MATHIS BAY ESTATES SUBDIVISION

APPLICATION NUMBER 17 DATE January 15, 2015

REQUEST Subdivision

DETAIL SITE PLAN

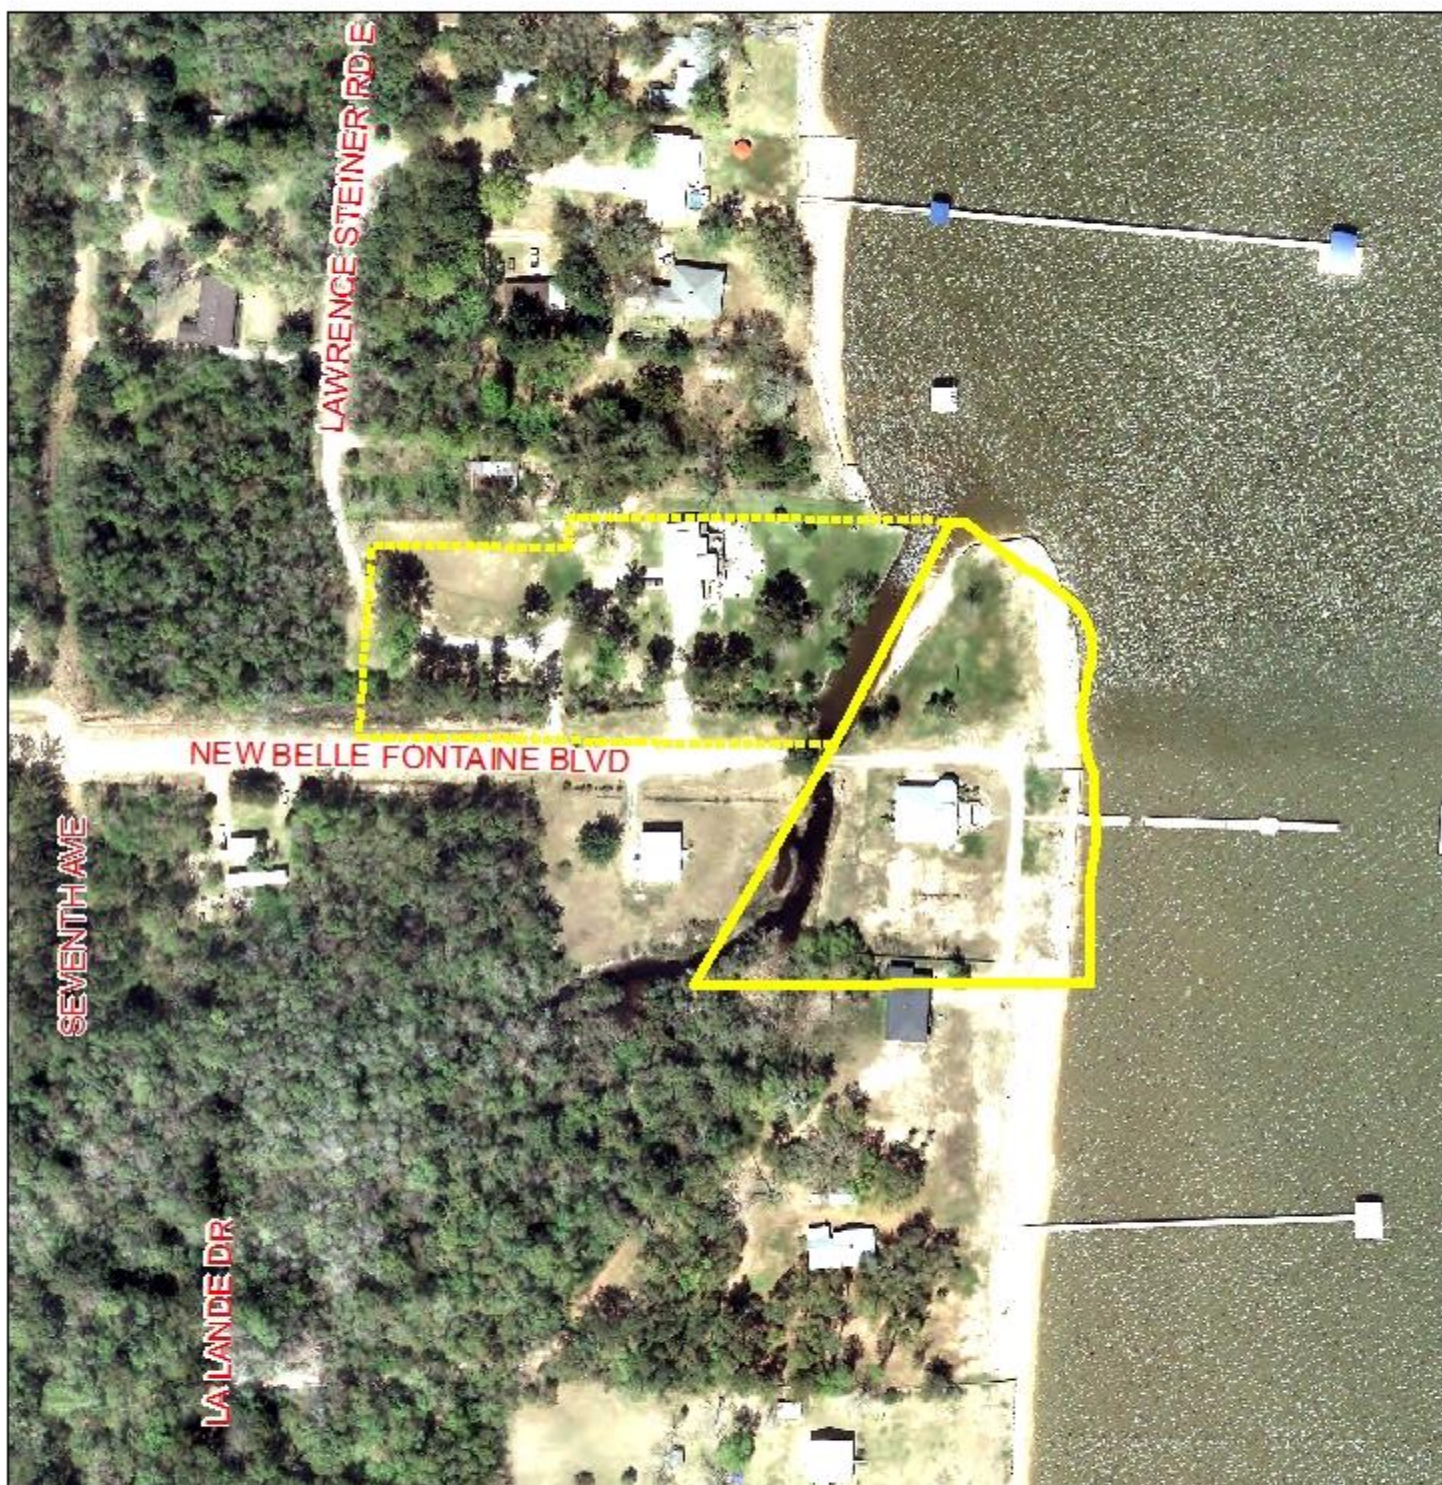
The site fronts on New Bellefontaine Boulevard, a minor street with a compliant 75' right-of-way; therefore, no dedication would be required. If the Subdivision is approved, as a means of access management, a note should be required on the Final Plat stating that each lot is limited to one curb cut to New Bellefontaine Boulevard, with the size, location and design to be approved by County Engineering and conform to AASHTO standards.

The plat indicates a 25' building setback line for all lots and this should also be shown on the Final Plat, if approved. All lots meet the minimum size requirements of the Subdivision Regulations and are labeled with their sizes in both square feet and acres on the preliminary plat. If approved, the Final Plat should retain these size labels, or a table should be furnished on the Final Plat providing the same information.

There are existing and proposed easements within the site; therefore, if approved, a note should be required on the Final Plat stating that no structures are to be constructed within any easement.

Lots 2 and 3 would be flag lots which are generally discouraged by Section V.D.1. of the Subdivision Regulations. However, they are permitted only in instances of family subdivisions or in those locations where varied and irregularly-shaped lot designs are common and the informality of design is consistent with other lots in the vicinity. There have been other flag lot

subdivisions allowed by the Commission within the vicinity and this particular subdivision would be similar. Therefore, a waiver of Section V.D.1. of the Subdivision Regulations would be in order, if approved. A note should be required on the Final Plat stating that no further resubdivision of any lot is allowed until additional public street frontage is provided.

No Flood Zone data was given on the preliminary plat. However, GIS data indicates the site to be within the VE Flood Zone. The presence of a floodplain indicates that the area may be environmentally sensitive; therefore, the approval of all applicable federal, state and local agencies would be required prior to the issuance of any permits or land disturbance activities.

It should be noted that when the two subject lots were created via the Resubdivision of Lot 302 and a Portion of Lot 301, Gray's Belle Fontaine Shores Subdivision, a note was placed on the Final Plat specifically stating that Lots 2 and 3 will not be resubdivided unless additional frontage and access is provided. New Bellefontaine Boulevard was indicated with a 75' right-of-way width for that Subdivision, the same as for the current. No additional frontage or access is now provided, and no justification for the non-adherence to that note is given.

With a waiver of Section V.D.1., the plat would ordinarily meet the minimum requirements of the Subdivision Regulations and be recommended for tentative approval. However, this particular Subdivision must be recommended for denial for the following reasons:

- 1) the subject site is restricted from further resubdivision by the note on the recorded plat of the Resubdivision of Lot 302 and a Portion of Lot 301, Gray's Belle Fontaine Shores Subdivision stating such; and
- 2) no justification for the non-adherence to that restriction was provided.
